REDLINE REVISION NO. 5
MD 175 AT DISNEY ROAD; REVISED POLE LOCATIONS IN THE NW QUADRANT
[signature] TEDD TEAM LEADER APPROVAL — 1/24/2013 DATE

MD 175 (ANNAPOLIS ROAD) AT
26TH STREET / DISNEY ROAD
FORT MEADE, MD

MOT PHASE 1B - TRAFFIC SIGNAL PLAN

SCALE 1″ = 20′	ADVERTISED DATE 4/26/1984	CONTRACT NO. AA 797-501-585	
DESIGNED BY MICKEY CORNELIUS		COUNTY ANNE ARUNDEL	
DRAWN BY MICKEY CORNELIUS		LOGMILE 02017507.10	
CHECKED BY		TIMS NO.	
F.A.P. NO. SEE TITLE SHEET		TOD NO.	
TS NO. 1959D1	DRAWING SG-03.1 OF 26	SHEET NO. 123 OF 195

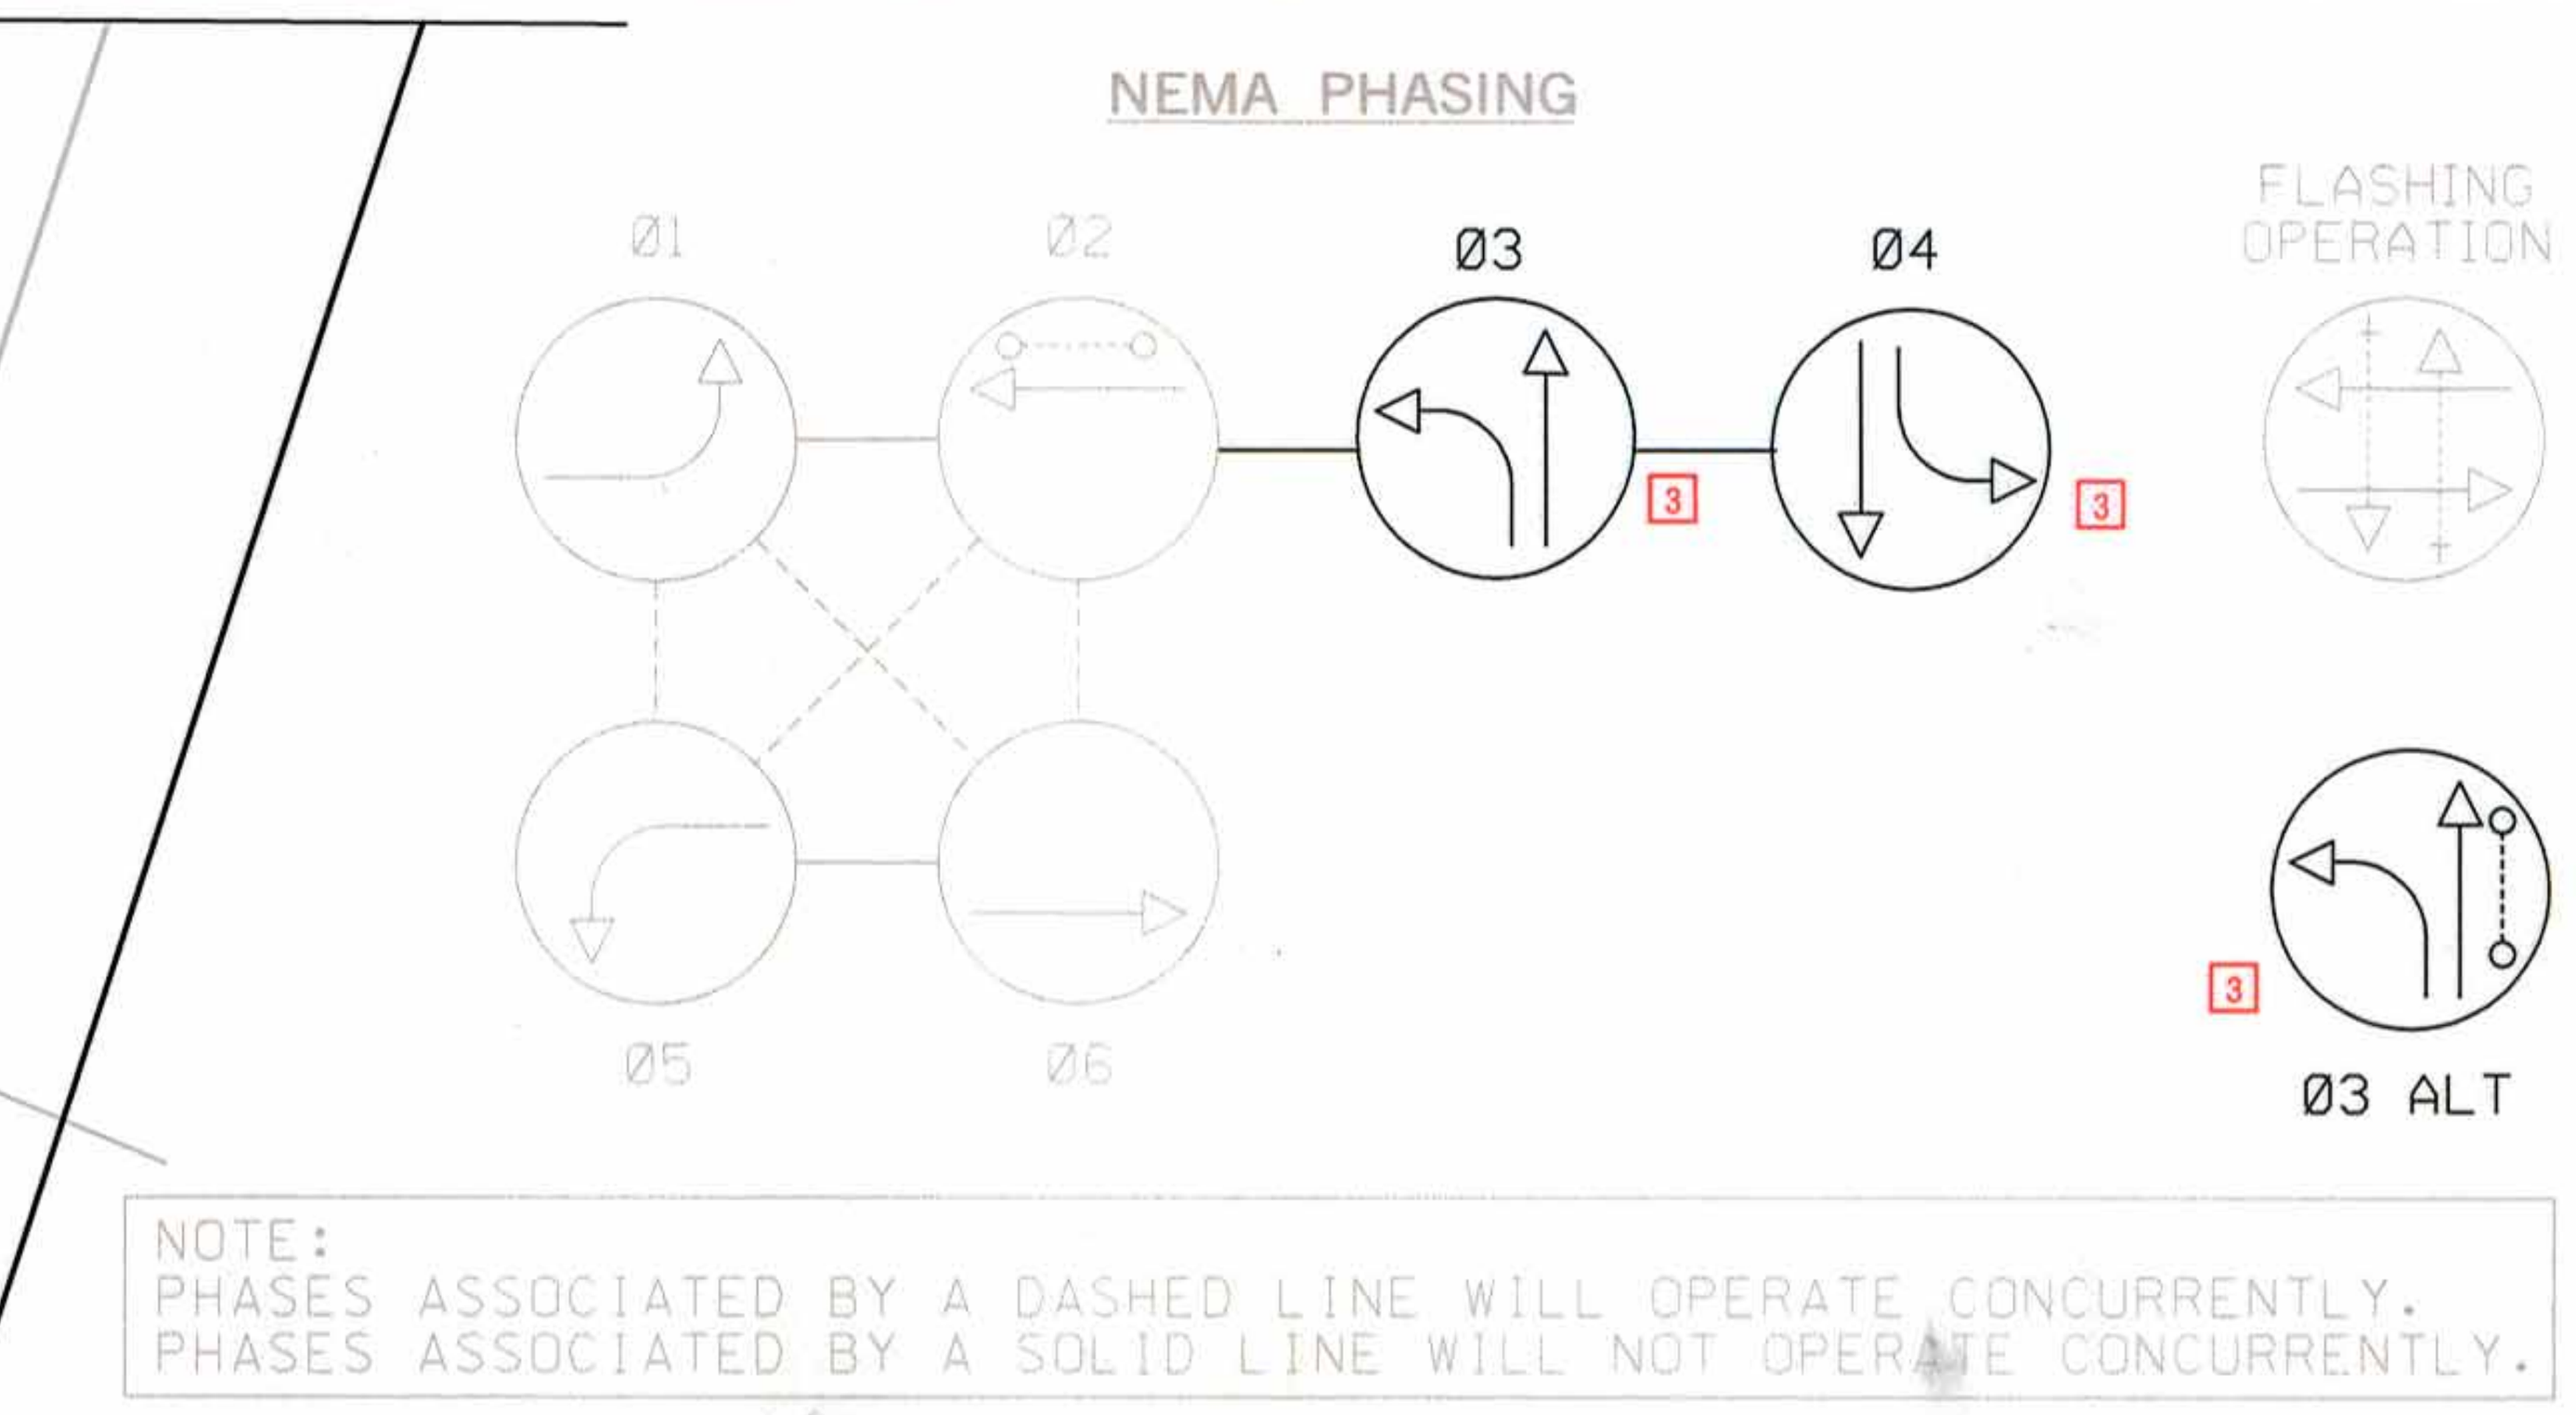
5. TEMPORARY SPAN WIRE SHALL BE MOUNTED AT 26′ ON THE MAST ARM UPRIGHT STRUCTURE AND HAVE A 5% SAG TO AVOID EXCESSIVE TENSIONING OF THE SPAN WIRE. MAINTAIN 17′ MINIMUM SIGNAL HEAD ROADWAY CLEARANCE. 5

D. INSTALL 27′ STEEL POLE WITH TWIN (70′/50′) MAST ARMS AT STA. 266+2.2, 58.3′ LT (50′ MAST ARM SHALL BE STORED FOR INSTALLATION DURING MOT PHASE 4); 3/8″ DIA. SPAN WIRE; 1/4″ TETHER WIRE ATTACHED; LED TRAFFIC SIGNAL HEADS; VIDEO DETECTION CAMERAS; SIGNS; 3″ WEATHERHEAD AND 15′ LIGHTING ARM WITH 250 WATT HPS LUMINAIRE (NOTE: 1-3″ 90° PVC BEND). PROPOSED WEST-BOUND TRAFFIC SIGNAL HEADS AND VIDEO DETECTION CAMERA SHALL BE ALIGNED WITH MOT PHASE 2 TRAVEL LANES. ALL PROPOSED SIGNAL HEADS SHALL BE BAGGED UNTIL MOT PHASE 2. ALL SIGNAL HEADS SHALL HAVE AN EXTRA 25′ OF CABLE FOR SIGNAL HEAD REPOSITIONING DURING UPCOMING CONSTRUCTION PHASES.

A. INSTALL NEMA SIZE ~~6″~~ 5 "S" BASE MOUNTED CABINET AND CONTROLLER WITH ALL NECESSARY EQUIPMENT.

~~D. INSTALL 27′ STEEL POLE WITH TWIN (70′/50′) MAST ARMS, LED TRAFFIC SIGNAL HEADS, VIDEO DETECTION CAMERAS, SIGNS, LED COUNTDOWN PEDESTRIAN SIGNAL HEAD WITH AUDIO PUSHBUTTON AND SIGNS, AND 15′ LIGHTING ARM WITH 250 WATT HPS LUMINAIRE (NOTE: 1-3″ 90° PVC BEND). PROPOSED WESTBOUND TRAFFIC SIGNAL HEADS ARE TO BE ALIGNED WITH MOT PHASE 2 TRAVEL LANES. ALL PROPOSED SIGNAL HEADS ARE TO BE BAGGED UNTIL MOT PHASE 2. ALL SIGNAL HEADS SHALL HAVE AN EXTRA 25′ OF CABLE FOR SIGNAL HEAD REPOSITIONING DURING UPCOMING CONSTRUCTION PHASES.~~ 5

~~J. INSTALL NEMA SIZE 5″ BASE MOUNTED CABINET FOR BATTERY BACKUP WITH ALL NECESSARY EQUIPMENT.~~ 5

APPROVALS	REVISIONS
TEAM LEADER	Ⓓ 5 REDLINE NO. 5 1/ /2013 INSTALL NEW PEDESTAL POLE IN THE NW QUADRANT, RELOCATE SIGNAL POLE — ENB
ASST. DIV. CHIEF	Ⓓ 3 REDLINE NO. 3 5/22/2012 SHOWING SIGNAL HEADS/PHASING FOR ORIGINAL LANE CONFIGURATION. — ENB
DIVISION CHIEF	Ⓓ BRAC RECONSTRUCT TRAFFIC SIGNAL SHA #. AA5805370 10/2010 TIMS NO. J-969 — ENB
OFFICE DIRECTOR (ORIGINAL ON FILE)
